THE SHOPS AT
PIPER GLEN

ALTERNATE SITE PLAN

SUBJECT: Administrative Change to Specific Plans for Parcel #4
of Petition No. 86-4(c)

SUBJECT: Administrative Approval to Specific Landscape Plan for Parcel #4 at
Piper Glen, Part of Petition No. 86-44(c), Tax Parcel No. 225-061-01,
225-011-03, 07, 225-021-01, 225-031-01, 225-041-01, 225-051-01.

SITE PLAN
SCALE 1"=40'-0"

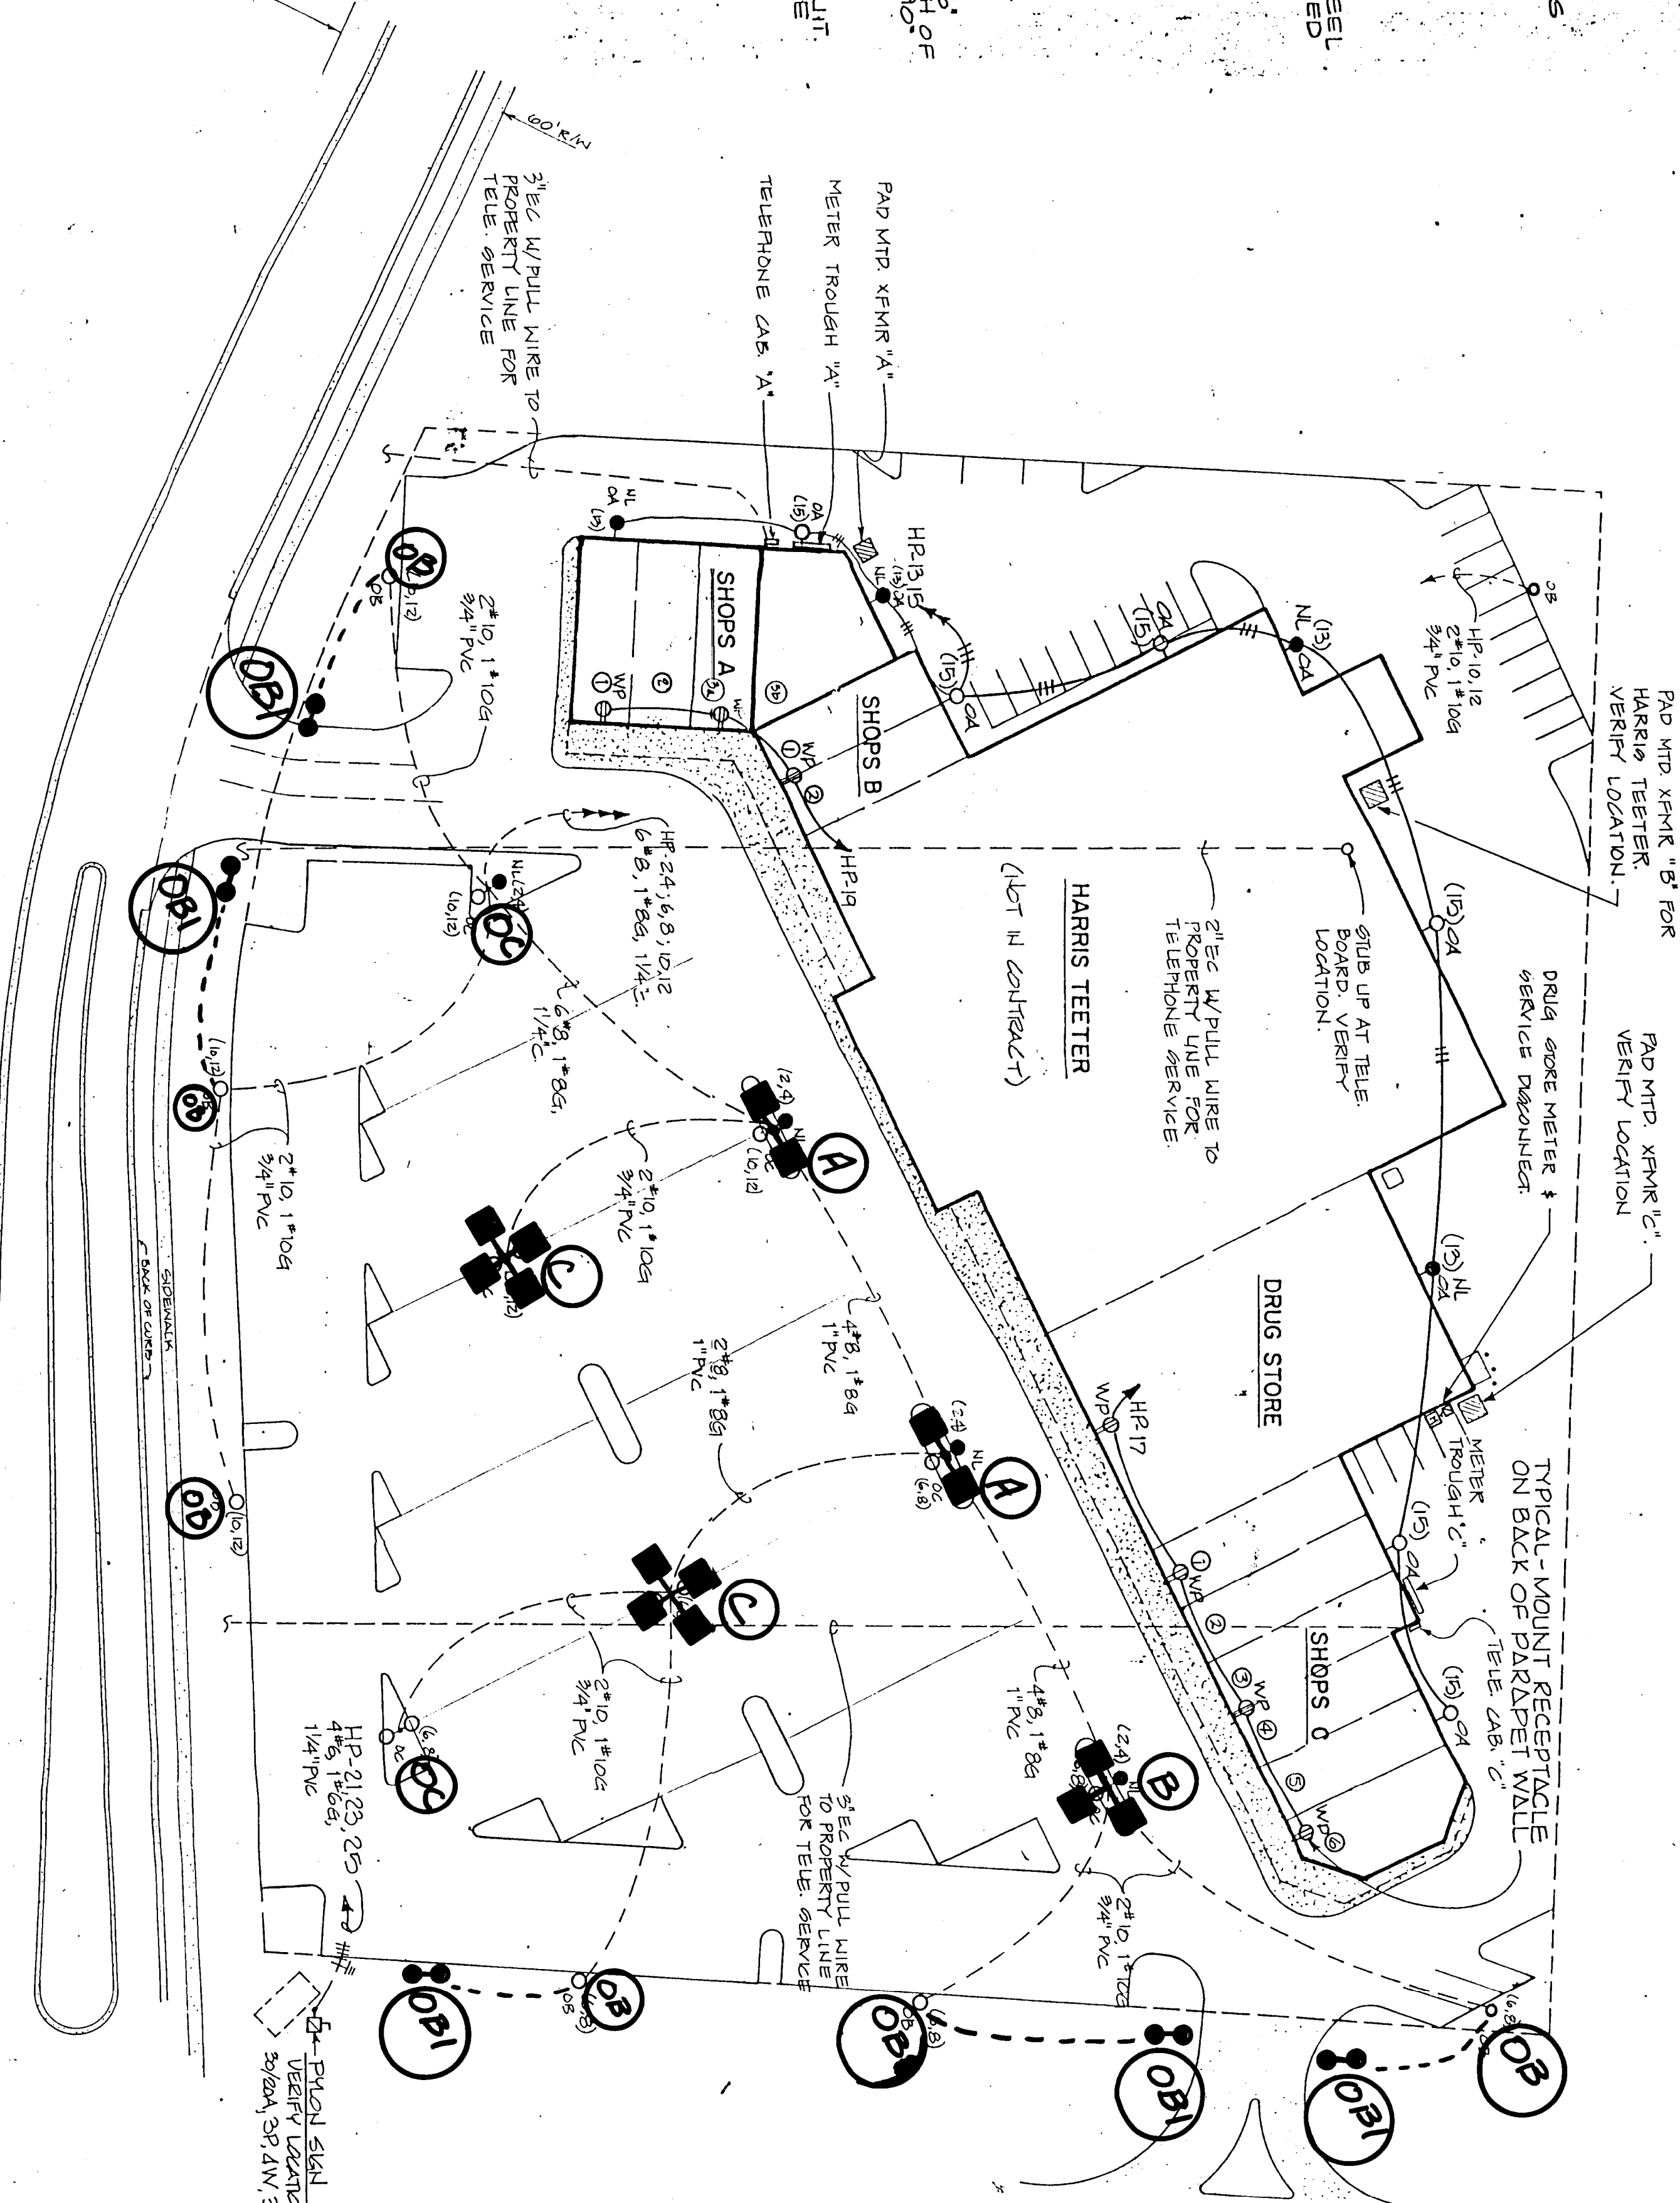
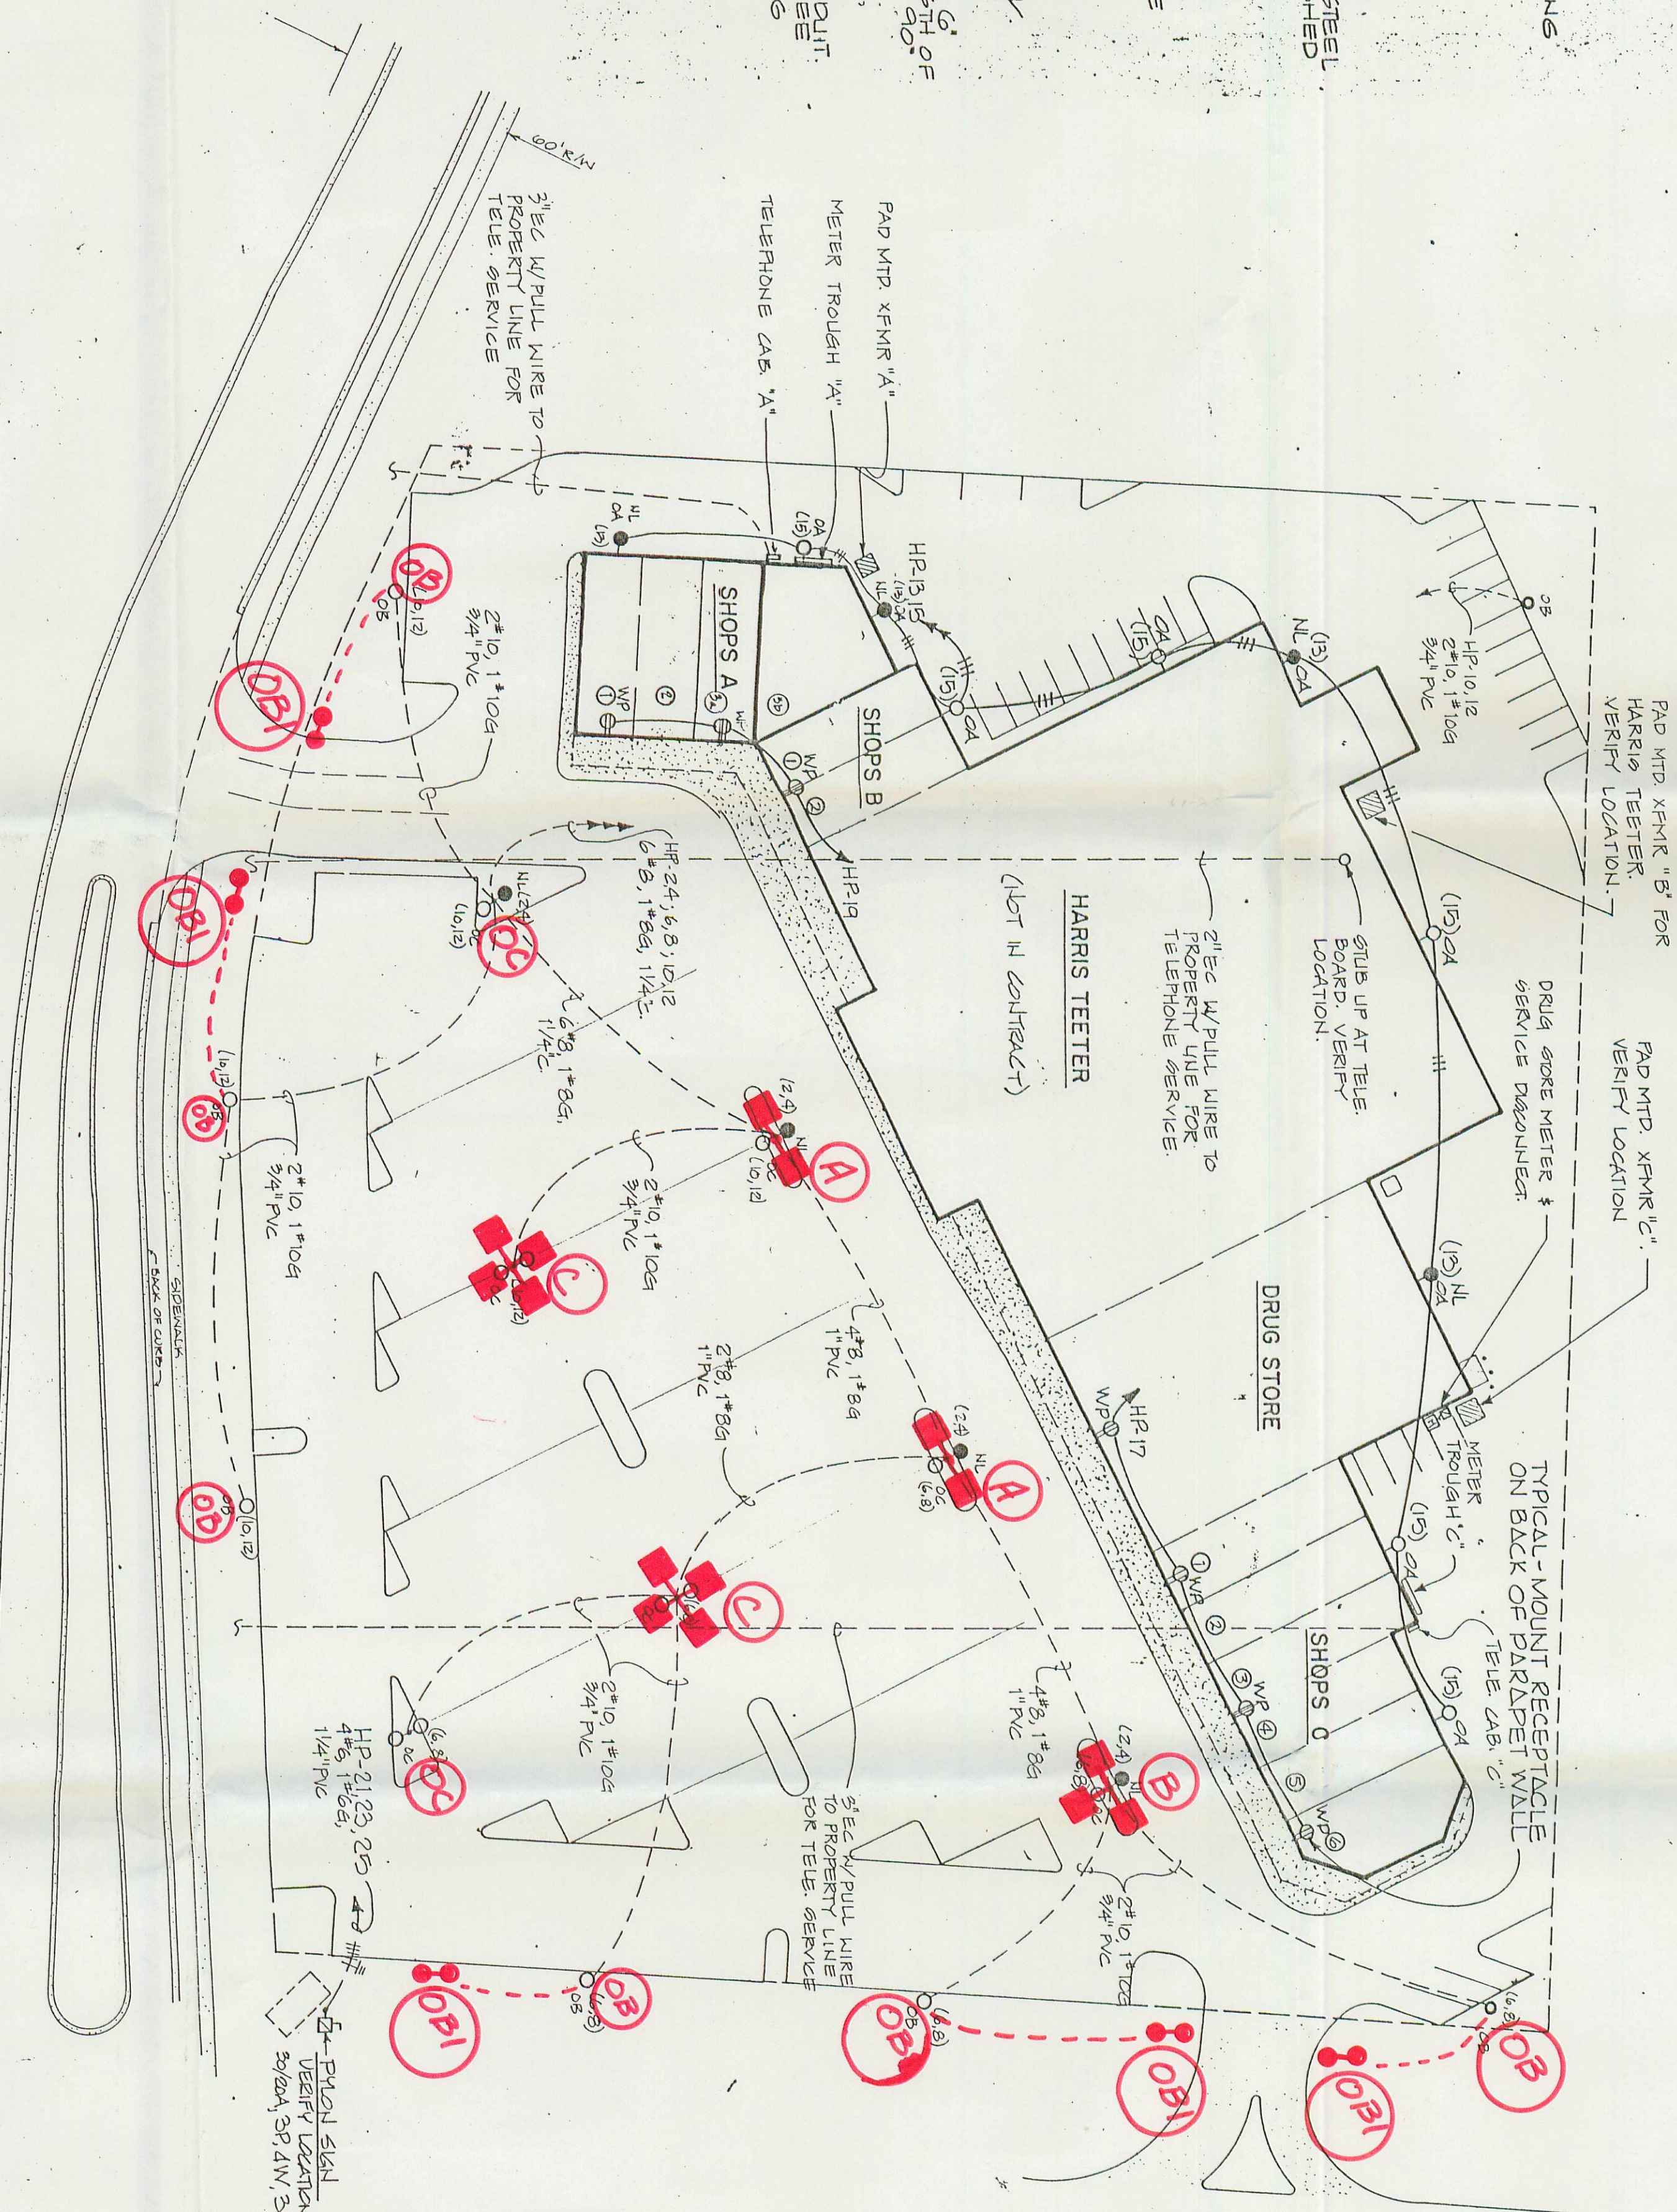
Attached is a revised site plan for the above mentioned rezoning petition this revised site plan demonstrates how the lighting for the shopping center is been revised to add five new lighting fixtures. These new fixtures will replace five existing fixtures. The existing fixtures will be placed at the perimeter of the site. We have looked at the effect these new lights will have on the adjoining properties and are satisfied that the effect will be negligible. Therefore we are administratively approving the addition of these light fixtures. Please use this plan when evaluating requests for building permits and certificates of occupancy.

If the new light poles displace any existing vegetation it must be replaced.
